☐	CAT - I	APPROVED - *No Further Comments*
☑	CAT - II	APPROVED - *Subjected to Incorporation of Comments as Marked.*
☐	CAT - III	NOT APPROVED *Resubmit with Incorporation of Comments as Marked / Discussed.*
☐	CAT - IV	INVALID SUBMISSION *Due to Non-Conformity of Tender specifications / drawings*

TITLE :-
DOUBLE WALL PUF INSULATED
MOTORISED ROLLING SHUTTER

CLIENT - RINAC
PROJECT -ROLLING SHUTTER
FORMAT NO - NIHVA-DD-F-03
DWG. NO. : NIHVA/23-24/104 REV-01
SCALE: NTS WT: SHEET: 01 OF 01
ALL DIMENSION ARE IN mm
If any queries contact : design@nihva.com

TITLE :-
MOTORISED ROLLING SHUTTER

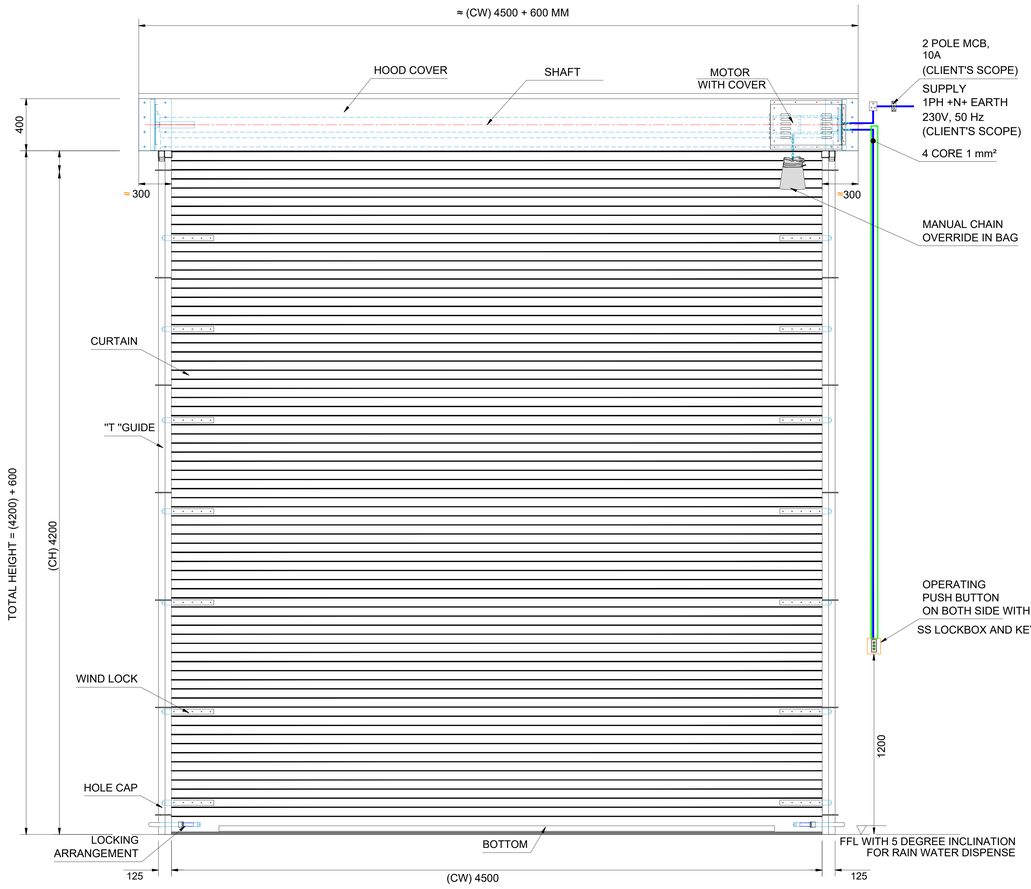
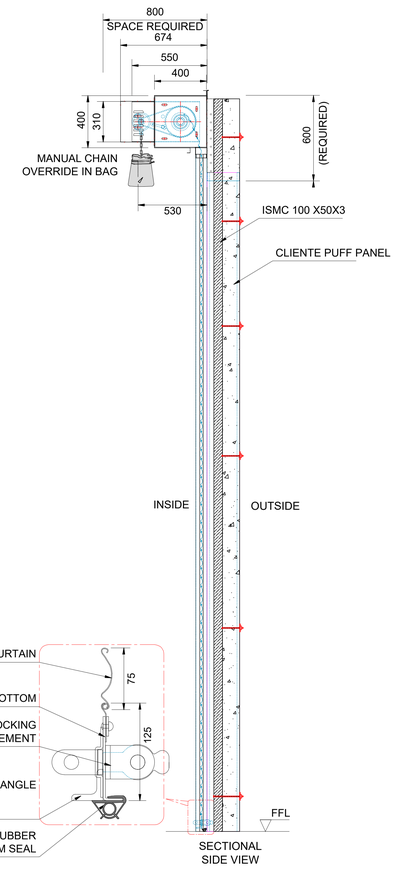
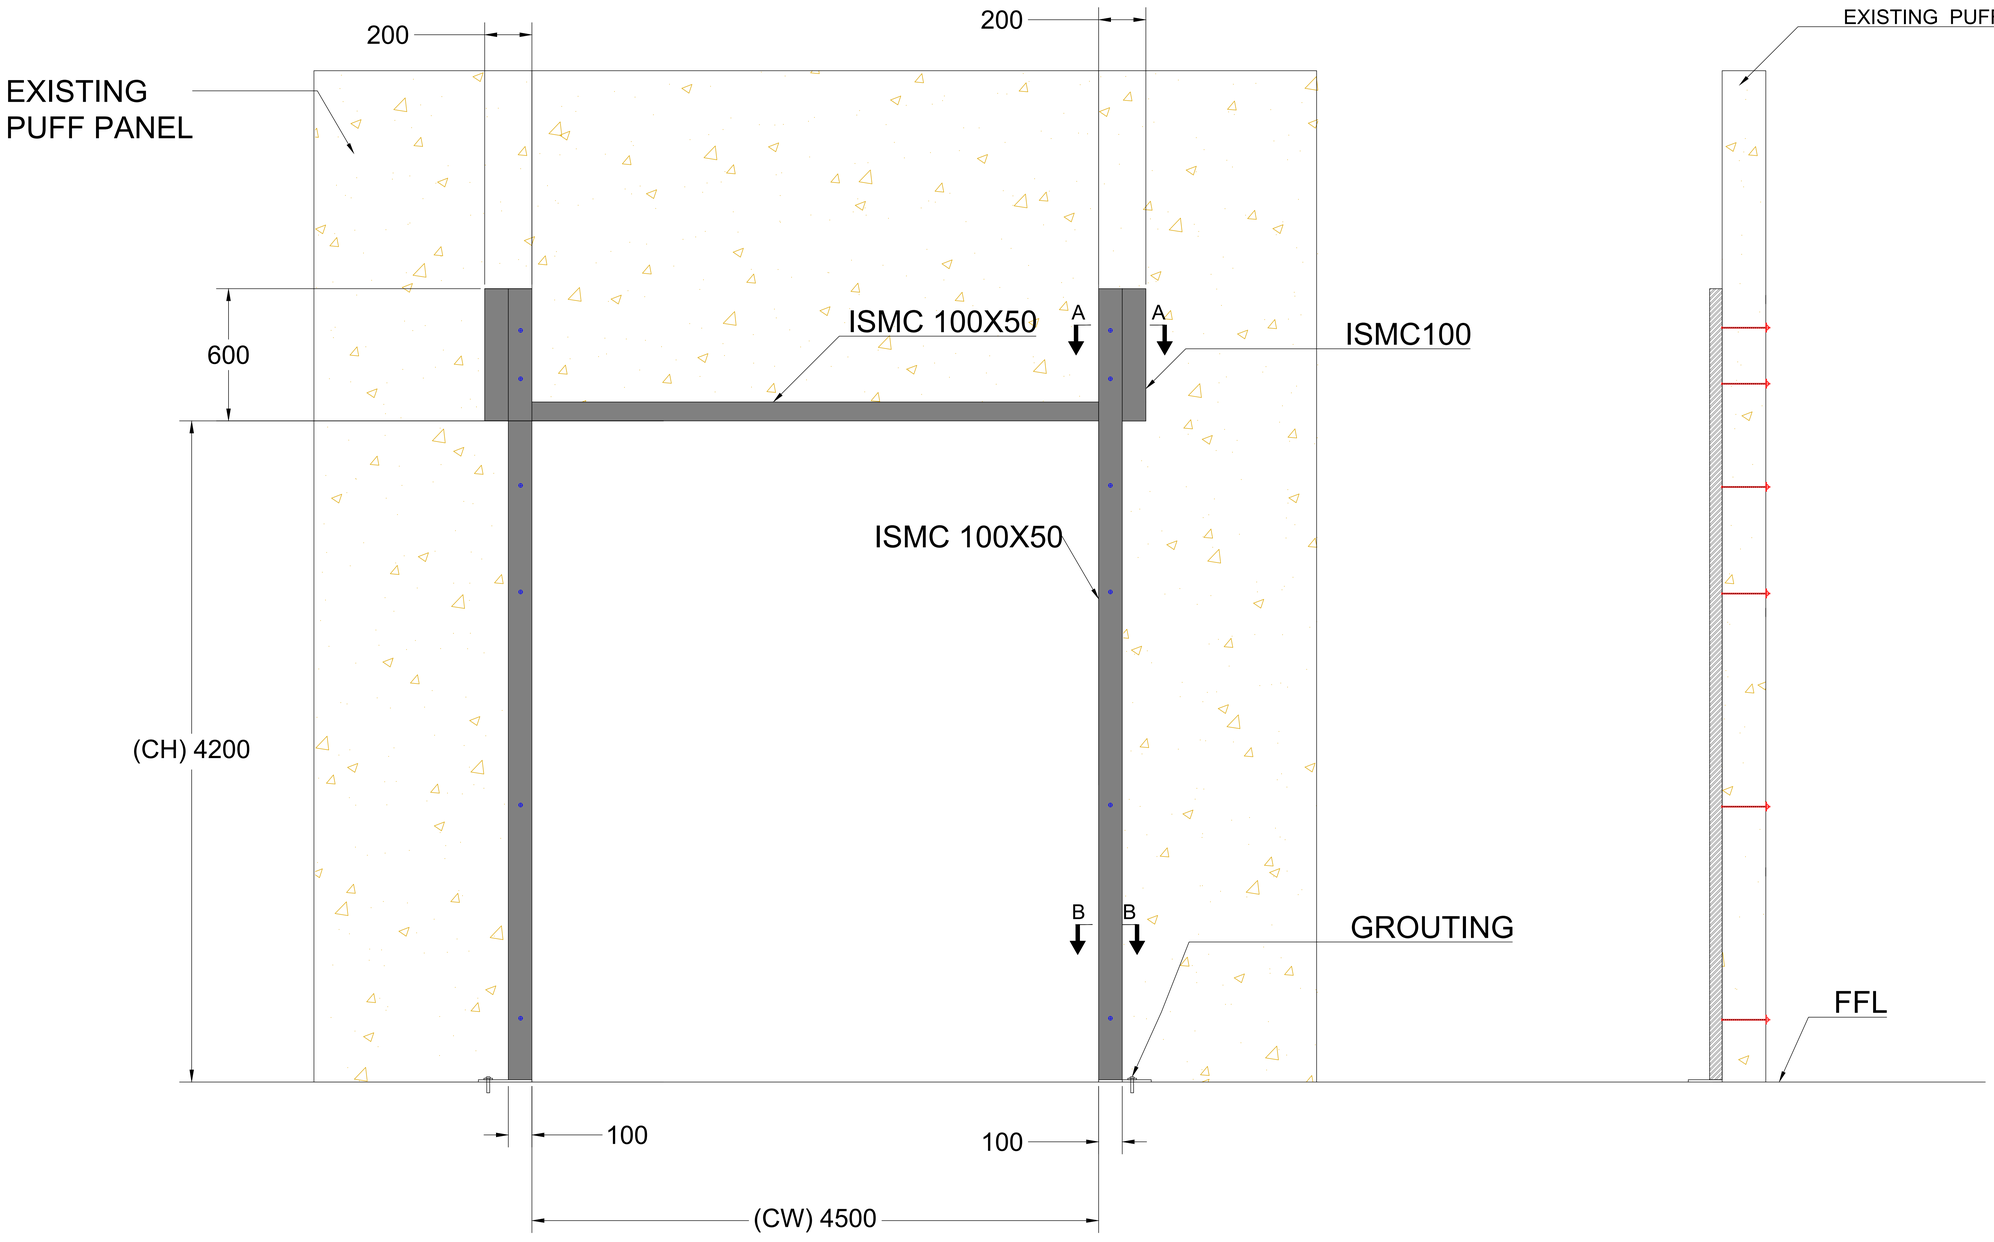
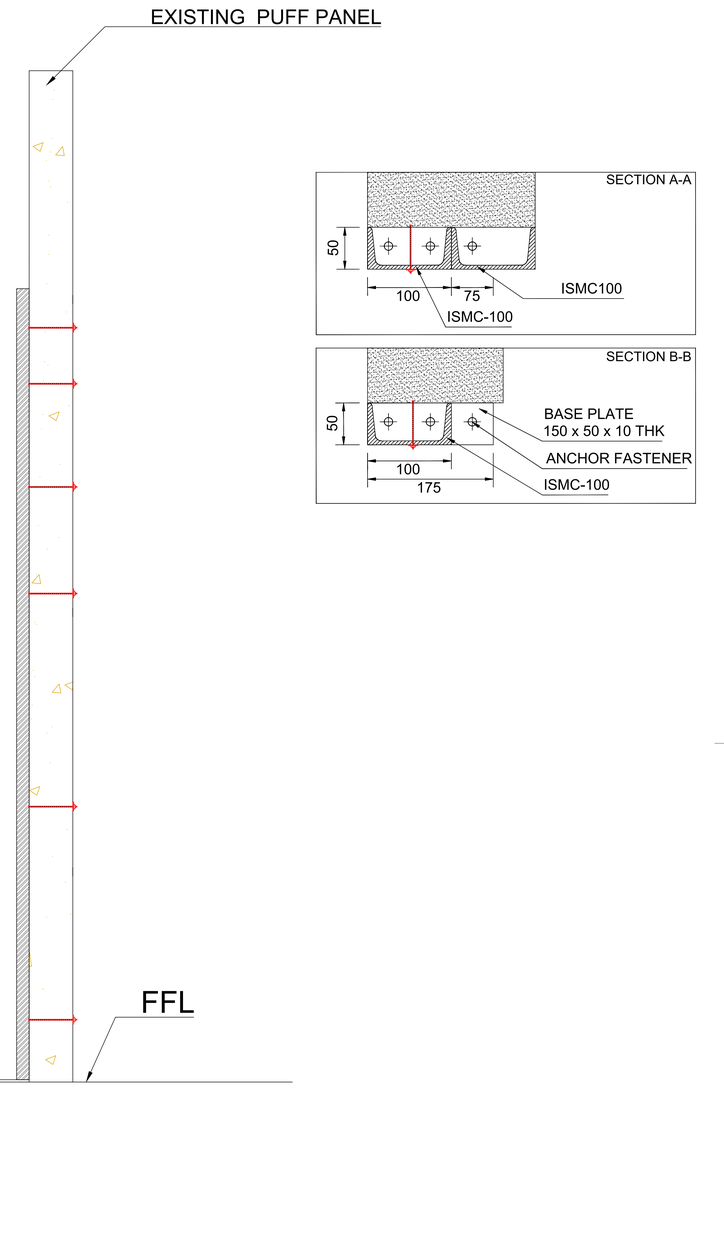
CAT - I	APPROVED - *No Further Comments*
CAT - II	APPROVED - *Subjected to Incorporation of Comments as Marked.*
CAT - III	NOT APPROVED *Resubmit with Incorporation of Comments as Marked / Discussed.*
CAT - IV	INVALID SUBMISSION *Due to Non-Conformity of Tender specifications / drawings*

COMMON COMMENTS :
1. CONTRACTOR NEEDS TO VERIFY THE DIMENSION OF THE OPENING ON SITE BEFORE PROCEEDING FOR EXECUTION
2. OPENING CONDITION OF THE ROLLING SHUTTER SHOULD BE AS PER THE PLAN
3. NO DEVIATION FROM TENDER SPECIFICATION WILL BE ALLOWED.
4. COLOR OF CURTAIN, BRACKET, SHAFT,SIDE GUIDES, BOTTOM PATTI, HOOD COVER PU SPRAY PAINTED SIMILAR TO RAL 9006 OVER 1COAT OF EPOXY PRIMER

TITLE :-
MOTORISED ROLLING SHUTTER

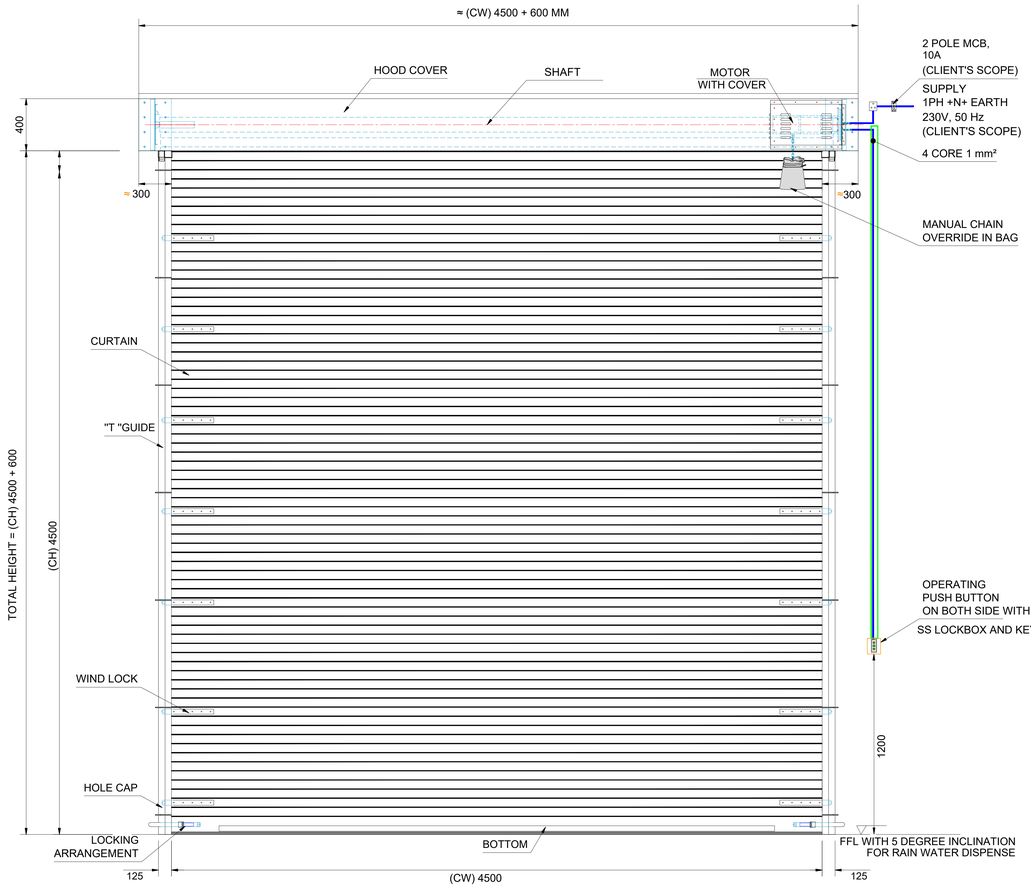
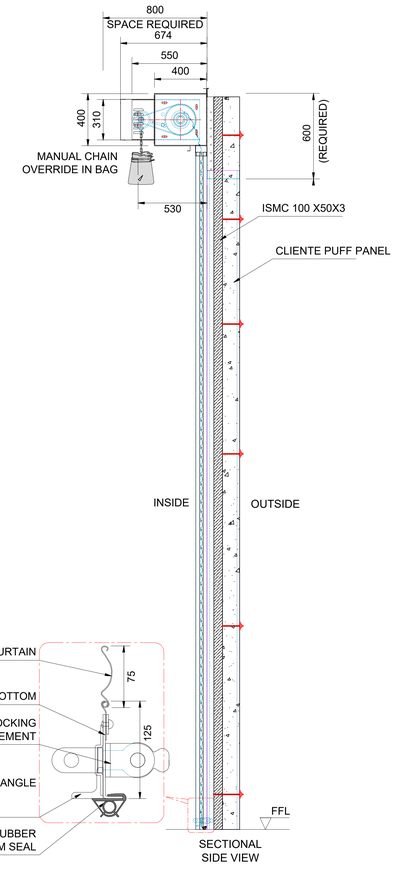
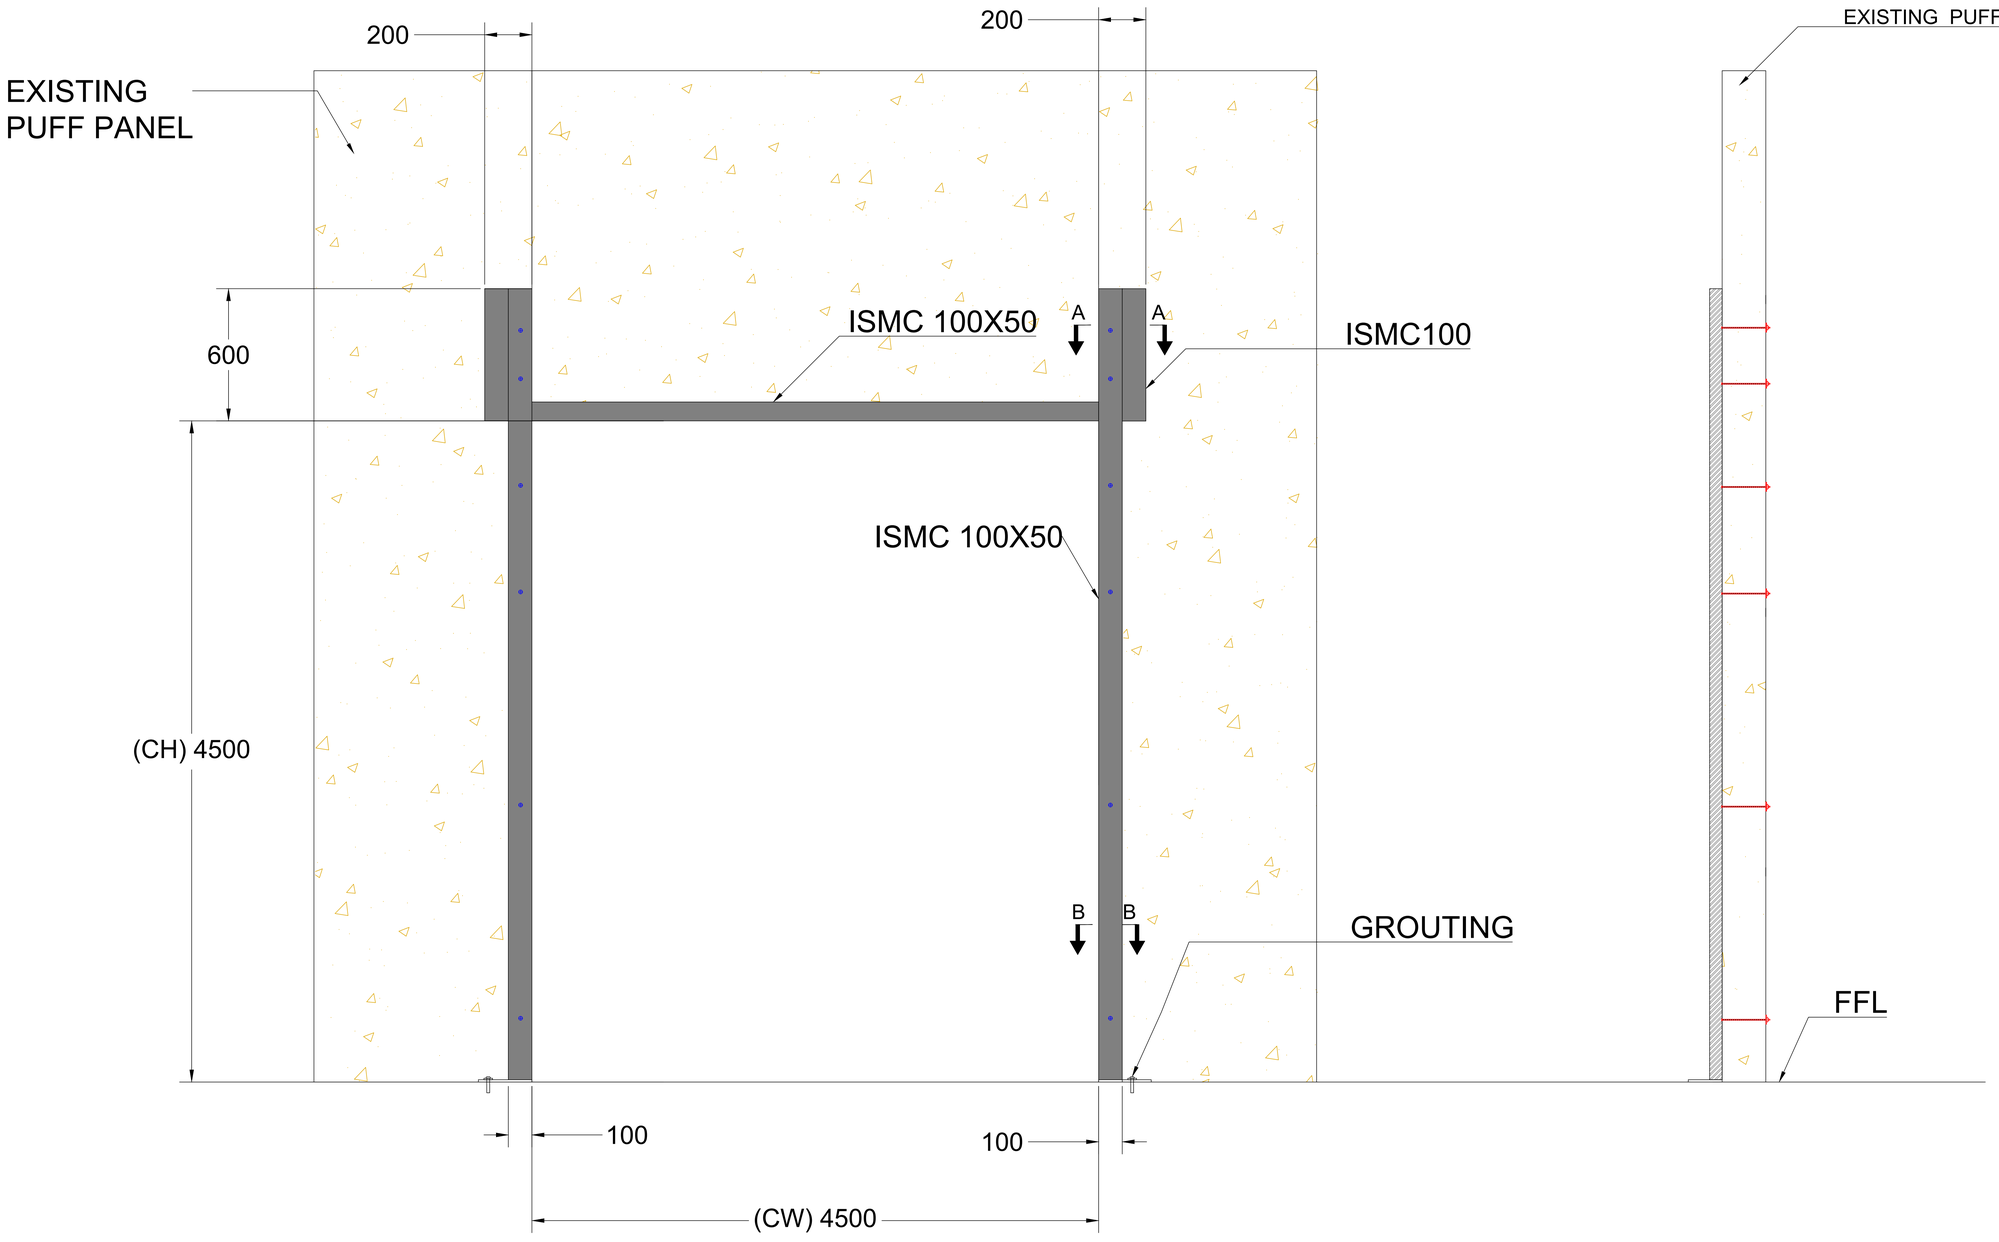
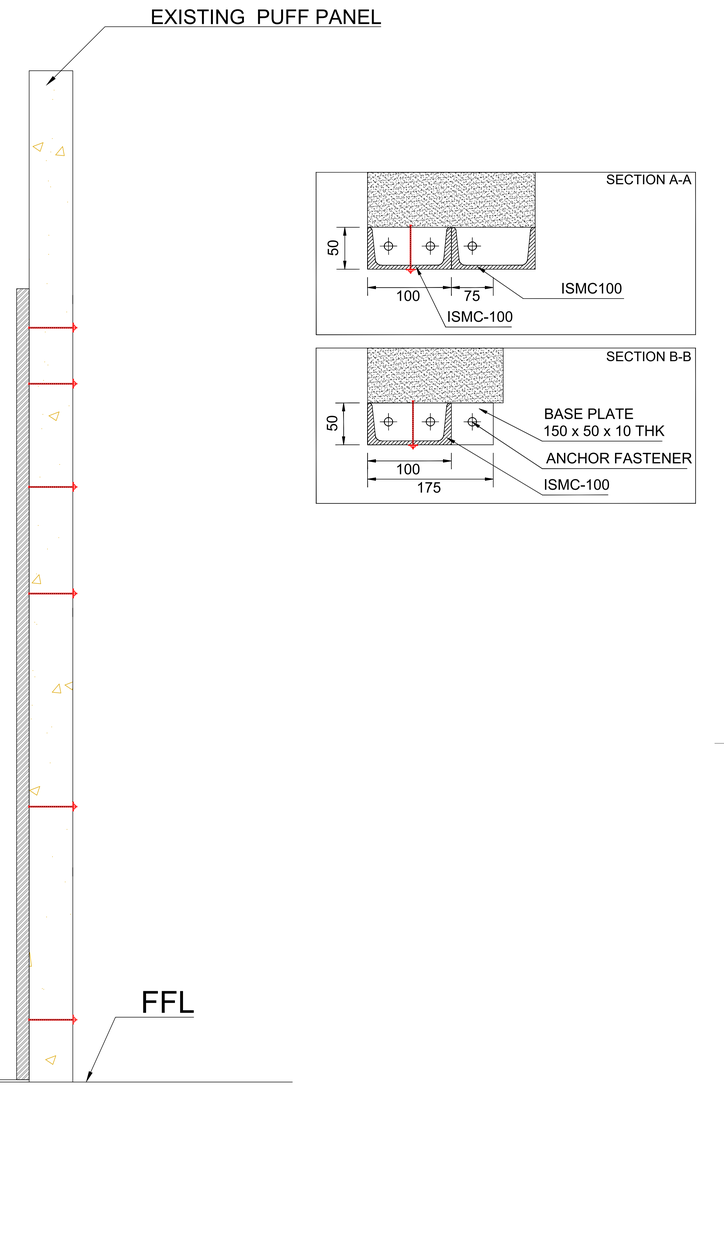
CAT - I	APPROVED - *No Further Comments*
CAT - II	APPROVED - *Subjected to Incorporation of Comments as Marked.*
CAT - III	NOT APPROVED *Resubmit with Incorporation of Comments as Marked / Discussed.*
CAT - IV	INVALID SUBMISSION *Due to Non-Conformity of Tender specifications / drawings*

COMMON COMMENTS :
1. CONTRACTOR NEEDS TO VERIFY THE DIMENSION OF THE OPENING ON SITE BEFORE PROCEEDING FOR EXECUTION
2. OPENING CONDITION OF THE ROLLING SHUTTER SHOULD BE AS PER THE PLAN
3. NO DEVIATION FROM TENDER SPECIFICATION WILL BE ALLOWED.
4. COLOR OF CURTAIN, BRACKET, SHAFT,SIDE GUIDES, BOTTOM PATTI, HOOD COVER PU SPRAY PAINTED SIMILAR TO RAL 9006 OVER 1COAT OF EPOXY PRIMER
